DEVIATION REQUEST AND DECISION FORM

Project Name : CLOVERLEAF FILING NO. 2
Schedule No.(s) : 7124202236, 7124202239, 7123103007, 7124202238
Legal Description : SEE ATTACHED – Exhibit B

A deviation from the standards of or in Section **ECM section 2.3 Roadway Design** of the Engineering Criteria Manual (ECM) is requested.

Walters Point Cross Section

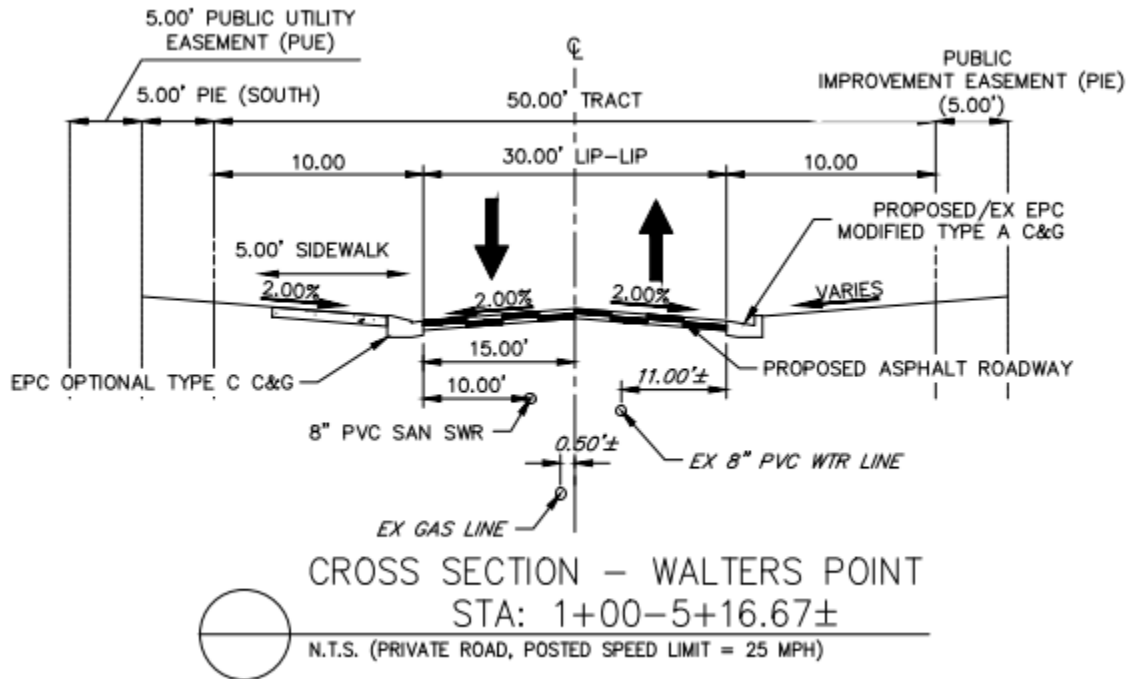
The developer requests a deviation from ECM table 2.7 – Local Roadway Design Standard be approved to delete the sidewalk on the north side of the roadway.

A deviation is requested to remove the sidewalk from the cross section on the north side of the road since Walters Point is an existing private roadway with no pedestrian walks adjacent to the private roadway, nor public walkways along Cloverleaf Road at its intersection with Walters Point.

See Exhibit A for a graphical representation of the roadway cross section.
